Town of Surfside

Construction of Town of Surfside 96th Street Park

Addendum No. 3

Date Issued: July 8, 2022

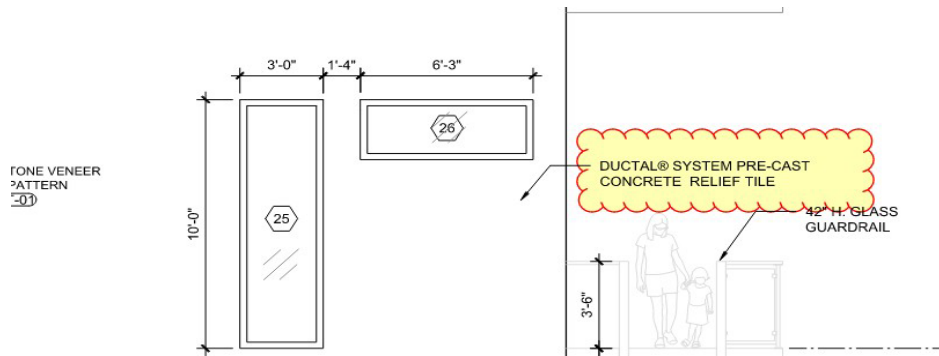
14. Please identify the difference between TR-01 and TR-02 finishes.

Both cement terrazzo.

2 NORTH ELEVATION
SCALE: 1/4" = 1'-0"

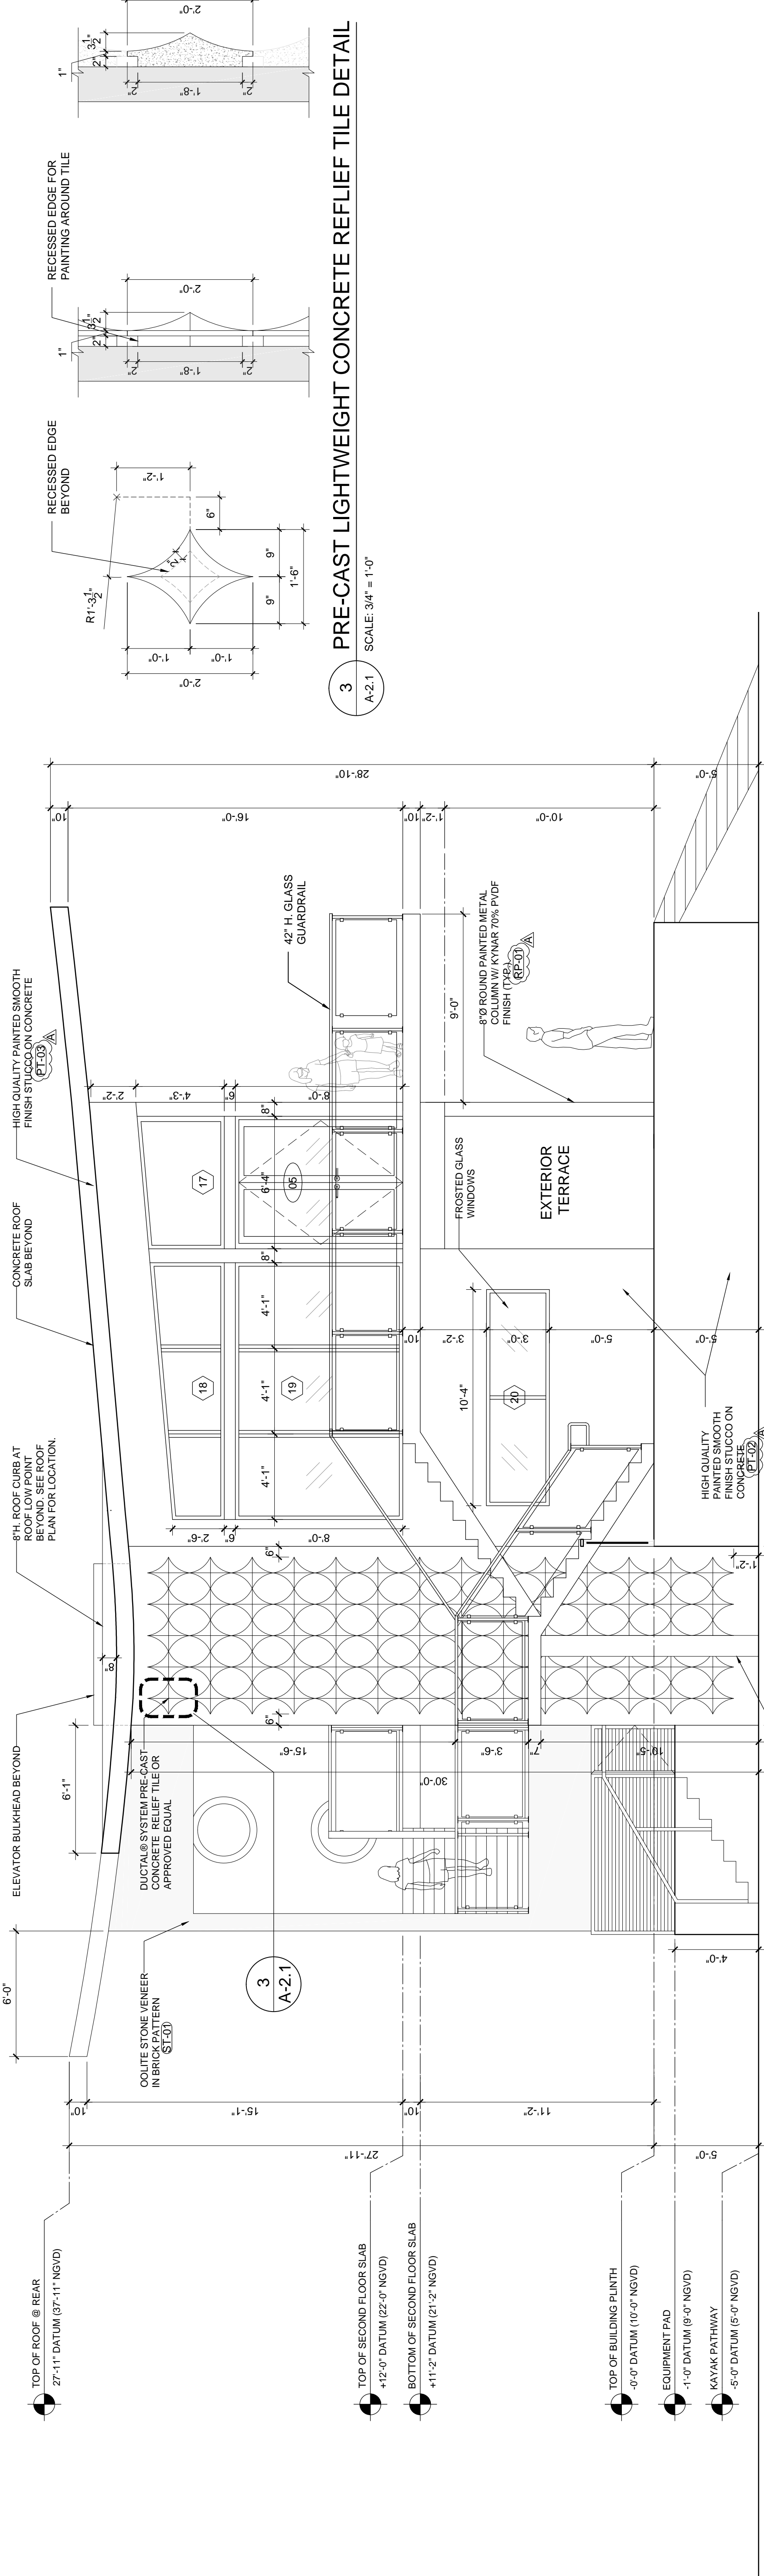
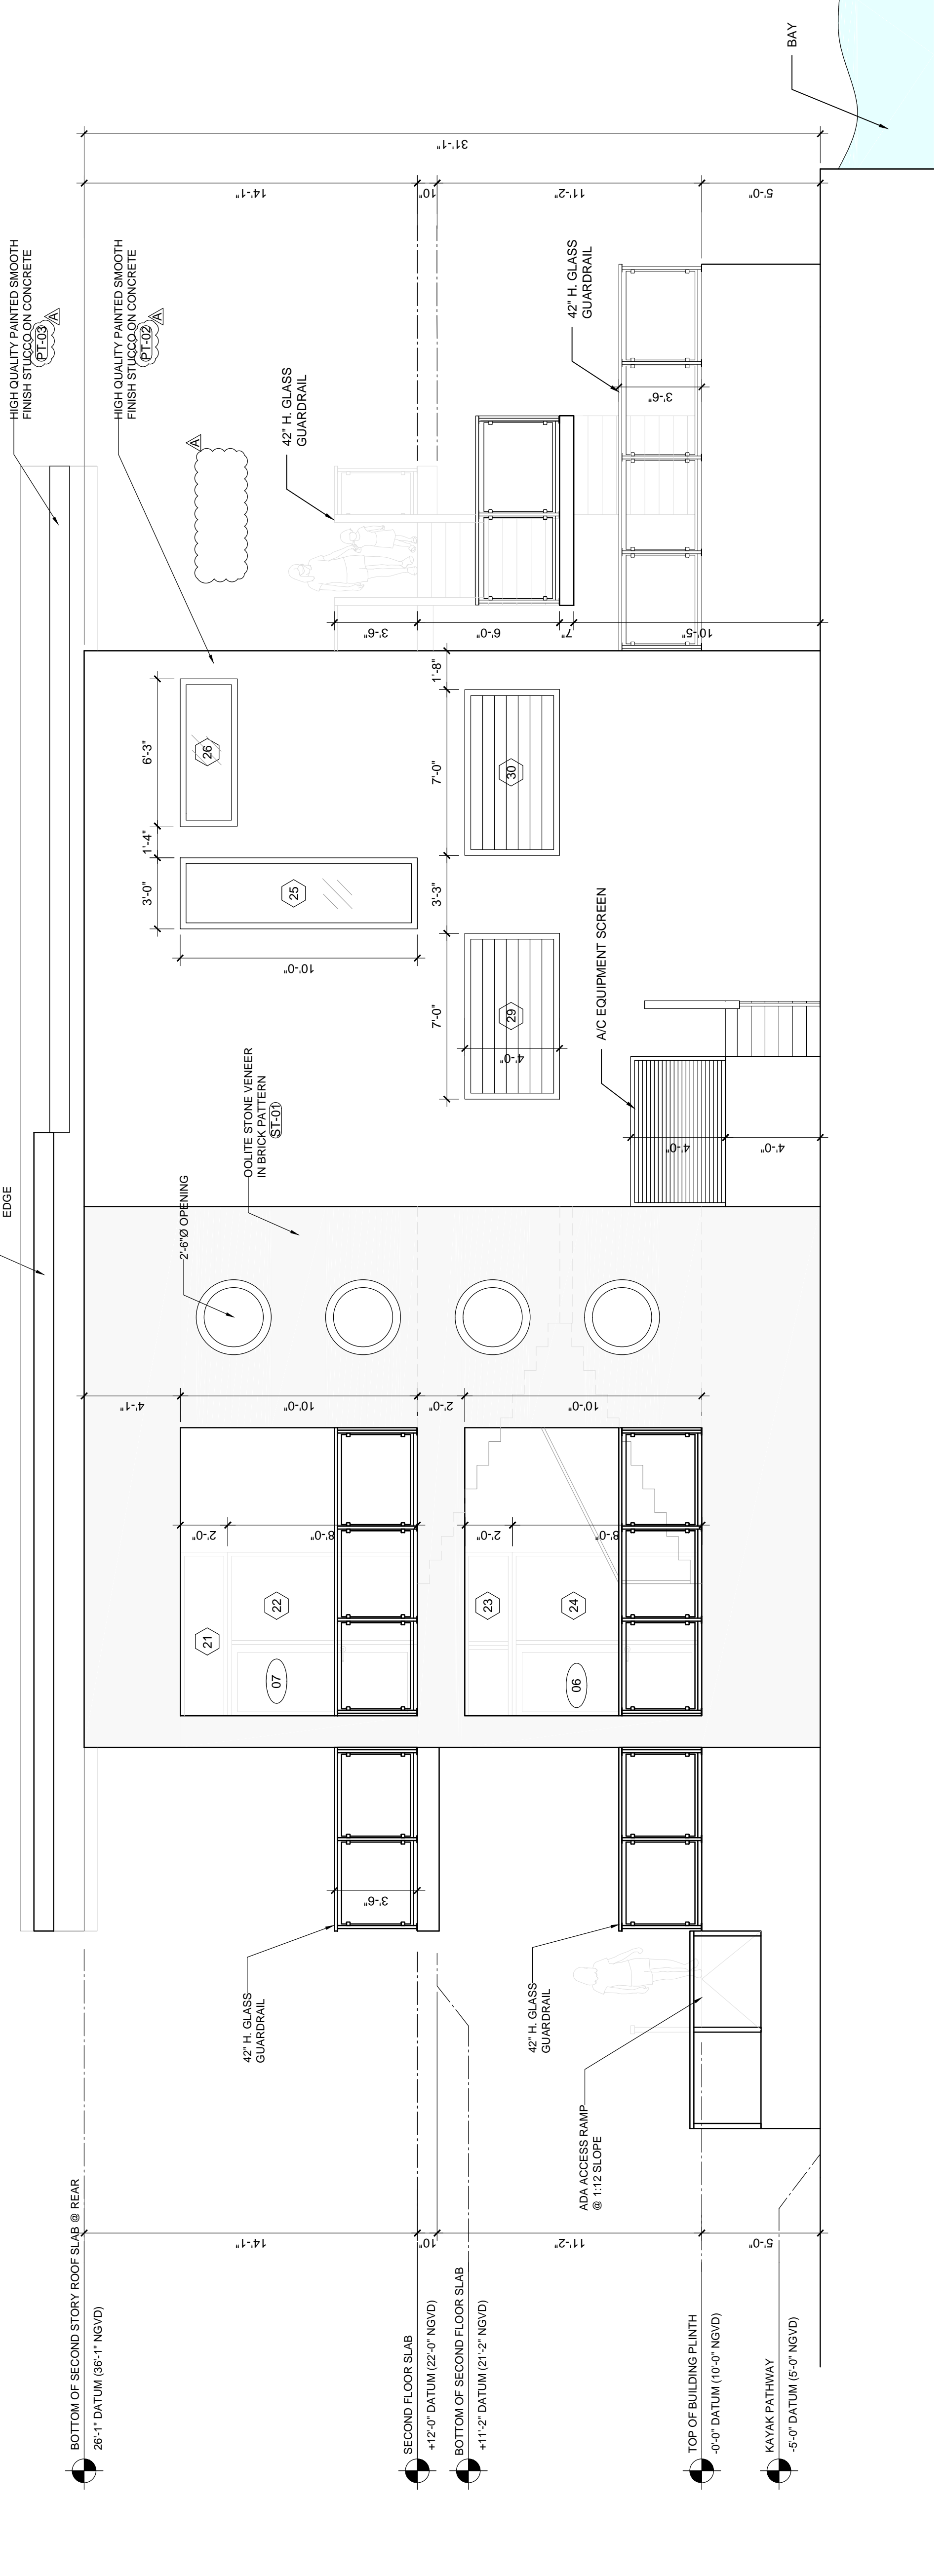
17. Sheet A-2.1 North Elevation has a call-out for Ductal System Precast Concrete Relief Tile, but nothing is shown in this area. Should this area be included as stucco?

Note removed - see updated sheet A-2.1

1 ROOF PLAN - ELECTRICAL
 SCALE: 1/4" = 1'-0"

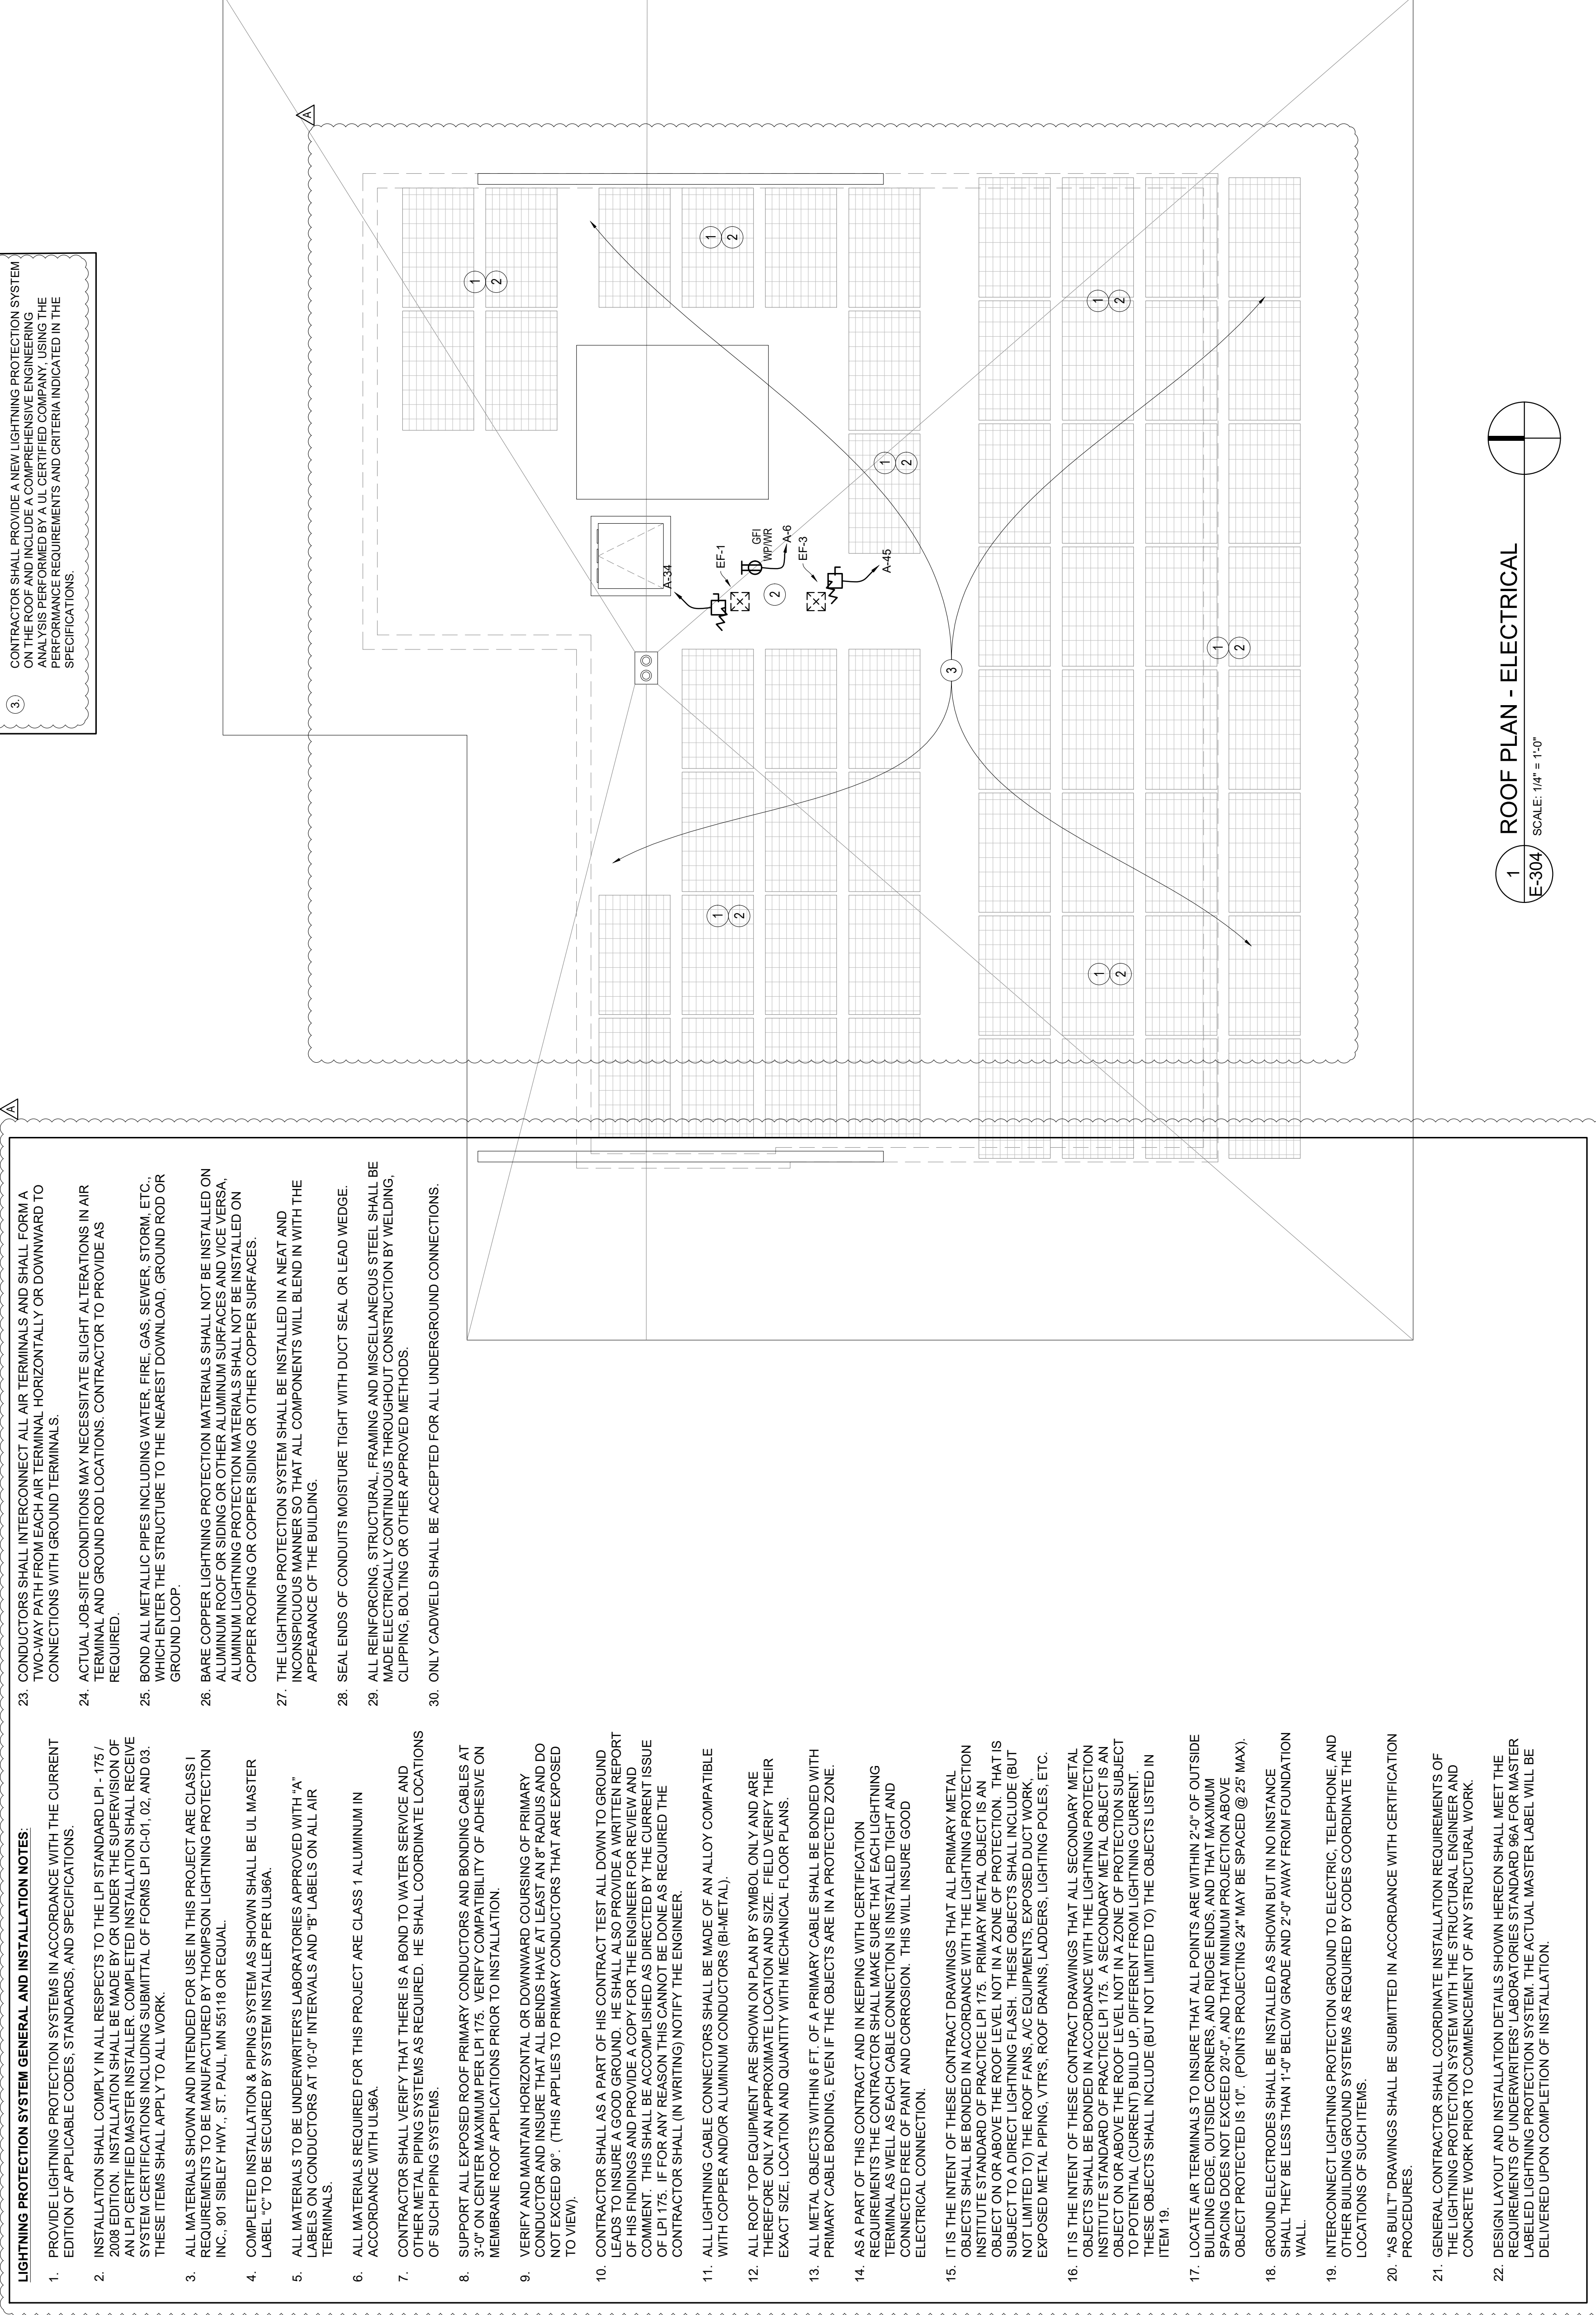
22. Is lightning protection required? If so, please provide specifications.

Yes, see revised plans E-304 and E-000 as well as added Specification 264113 – Lightning Protection for Structures.
